Aztec 35

Section 35 T30N R14W

APPLICATION FOR PERMIT TO DRILL, DEEPEN, OR PLUG BACK

SUNDRY NOTICES AND REPORTS ON WELLS

**NEW MEXICO OIL CONSERVATION COMMISSION
WELL LOCATION AND ACREAGE DEDICATION PLAT**

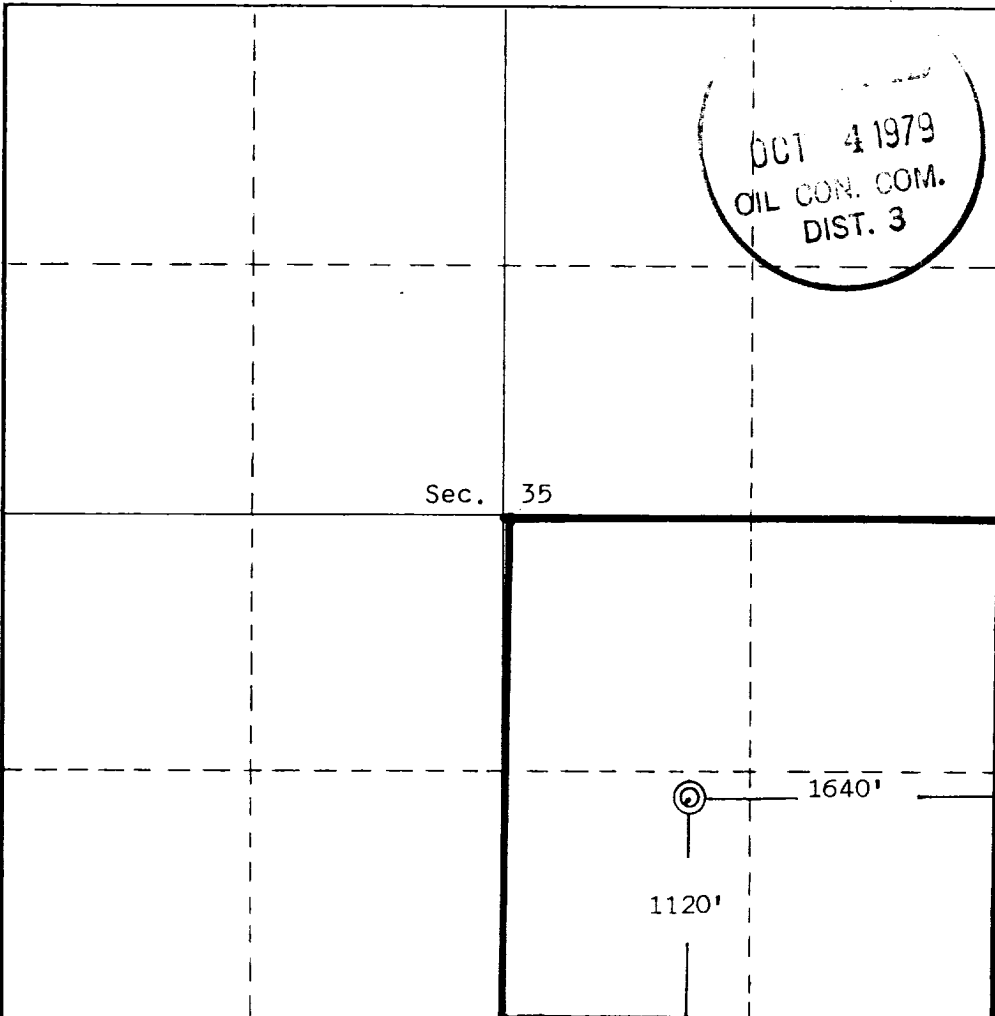
1. Change location of well per C-102
2. Plan to set 90' of 7" surface pipe and cement to surface w/20 sx
3. Plan to use BOP as required by USGS. (6" 600 series.)

SCHEMATIC DIAGRAM

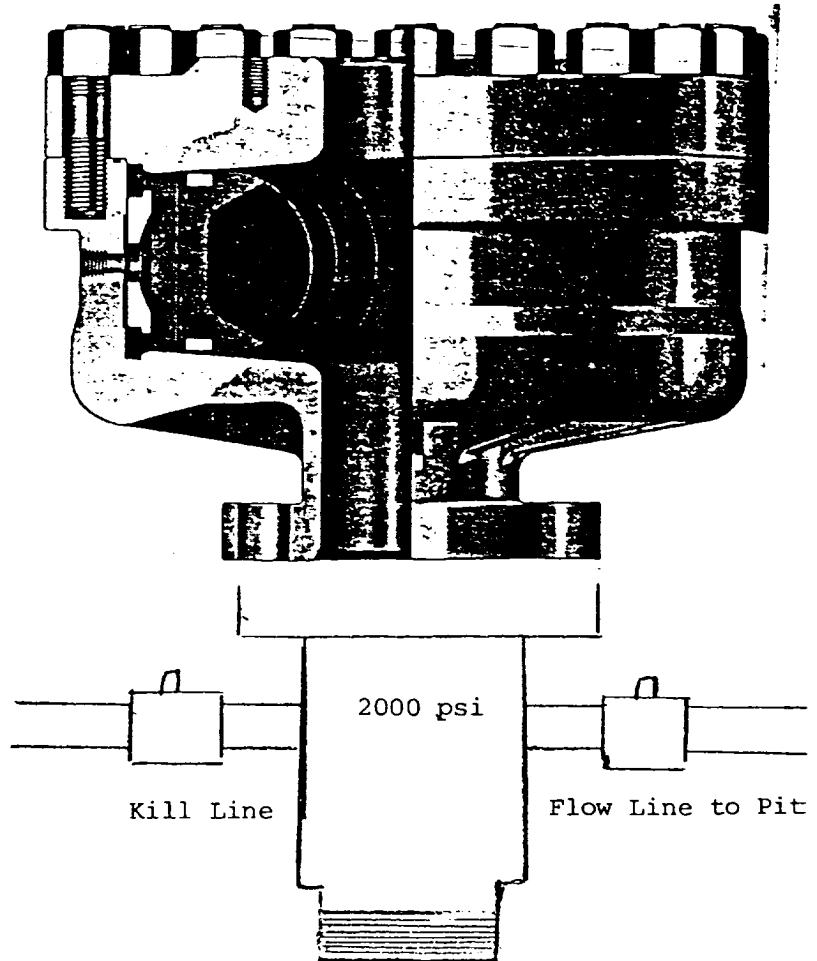
Install BOP after setting surface pipe and pressure test to 1000 psi after drilling out from under surface pipe.
